OFFICIAL STAR CLASS MEASUREMENT CERTIFICATE

1. YACHT'S NUMBER? 39692. Was this number cut or burned into keelson as required above? YES3. Yacht's name "SABINE II." 4. Year built 19585. By whom built? LORENZ HUBER6. Owner's Name FRITZ ESTERER7. Address ALT OTTING, BAYERN8. Fleet CHIENLER 9. Remarks**CERTIFIED MEASURER'S AFFIDAVIT**

Report from International Measurement Committee

Star No. 3969

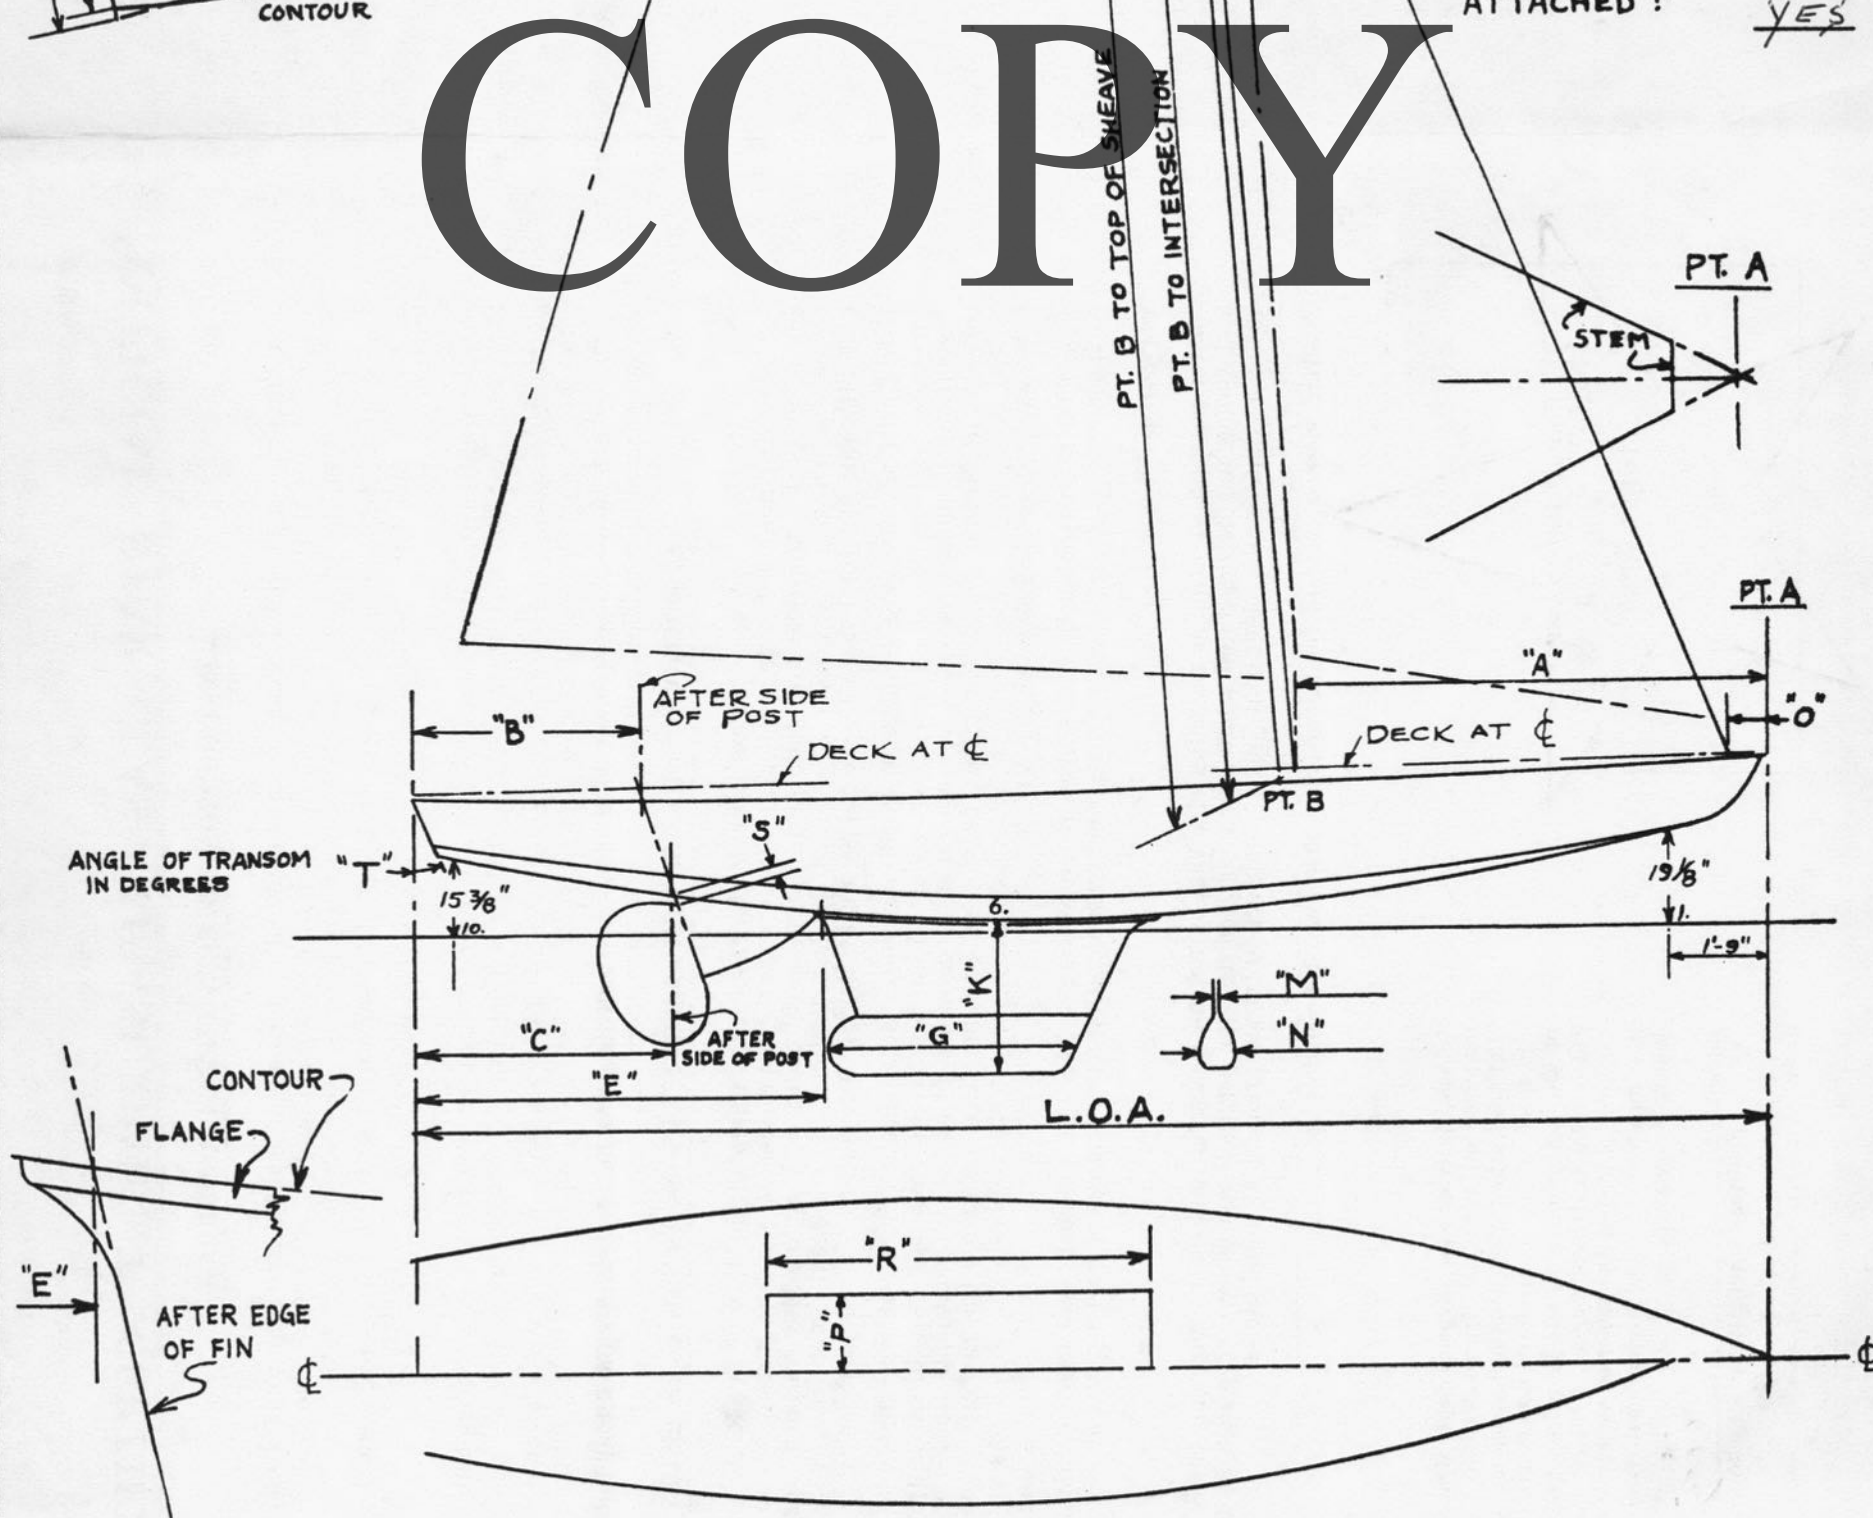
The Measurement Certificate for this boat cannot be approved due to the following points which do not comply with the Specifications:

CHINE HEIGHT (6) LISTED 228 MAX. 227
(8) LISTED 314 " 312

☒ The points in question must be remeasured by a Certified Measurer and the results submitted to the Measurement Committee.

☒ The points in question must be altered to conform to the Specifications and then remeasured by a Certified Measurer and submitted to the Measurement Committee.
